Access Compliance Report

Public Rights-of-Way

(Curb Ramps)

Intersection ID: 29303	Main Street: OAKDALE_GREEN_DR	Cross Street: WHISPERING_BROOK_CT	Location: W
ADA ID: BA7905B23E60	Ramp Type: BlendTrans1	Initial Pass/Fail: Fail	Overall Compliance: No
			Severity Score: 10

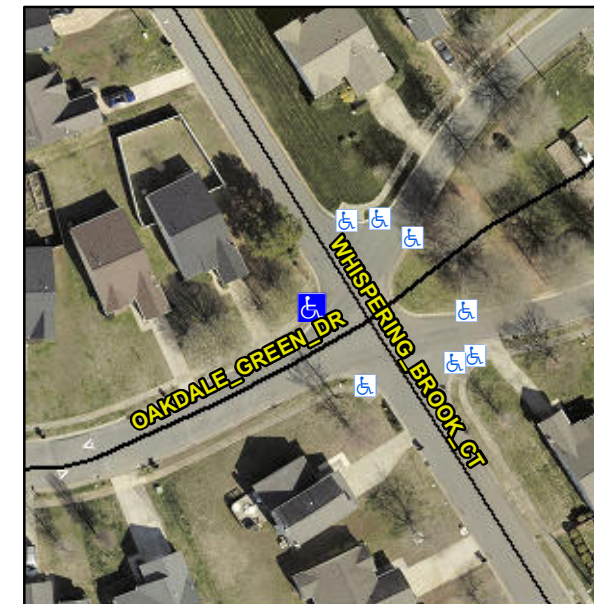
Not Found, R304.5.1, R304.5.3

Compliance	Description	Data	Compliance	Description	Data
N/A	Ramp Length (in)	46.0	Yes	BlendTrans Slope (%)	2.1
No	Ramp Width (in)	43.0	No	BlendTrans XSlope (%)	2.1
N/A	Flare Type LT	N/A	N/A	Flare Type RT	N/A
N/A	Flare Slope LT (%)	N/A	N/A	Flare Slope RT (%)	N/A
N/A	Flare Traversable LT?	N/A	N/A	Flare Traversable RT?	N/A
N/A	Landing Length (in)	N/A	N/A	DWS Provided?	N/A
N/A	Landing Width (in)	N/A	N/A	DWS Contrast?	N/A
N/A	Landing Slope (%)	N/A	N/A	DWS Length (in)	N/A
N/A	Landing X Slope (%)	N/A	N/A	DWS Full Width?	N/A
N/A	Landing Curb? (Y/N)	N/A	N/A	DWS Offset (in)	N/A
N/A	Shared Landing?	N/A			
N/A	Gutter Ponding?	N/A	N/A	Gutter Slope (%)	N/A
N/A	Gutter Lip Ht (in)	N/A	N/A	Gutter X Slope (%)	N/A
N/A	Painted X Walk1?	No	N/A	Painted X Walk2?	No
	X Walk 1 Direction	To NE		X Walk 2 Direction	To SE
	X Walk 1 Width (in)	N/A		X Walk 2 Width (in)	N/A
	X Walk 1 Slope (%)	3.8		X Walk 2 Slope (%)	3.4
	X Walk 1 X Slope (%)	5.7		X Walk 2 X Slope (%)	2.1

N/A	Ramp inside XWalk1?	N/A	N/A	Ramp inside XWalk2?	N/A
	Road Slope (%)	2.6		Clear Space?	N/A
	Road X Slope (%)	9.9	N/A	Clear Space to XWalk (in)	N/A
N/A	Any Obstructions?	N/A	N/A	Storm Grate/Utility Hazard?	N/A
	Obstruction Type			Storm Grate/Utility Type	
		N/A			N/A
			Yes	Surface Condition? (G/P)	Good
			No	Curb Slope (%)	17.8

Remove & Replace Curb Ramp With Two New Directional Ramps or Equivalent.
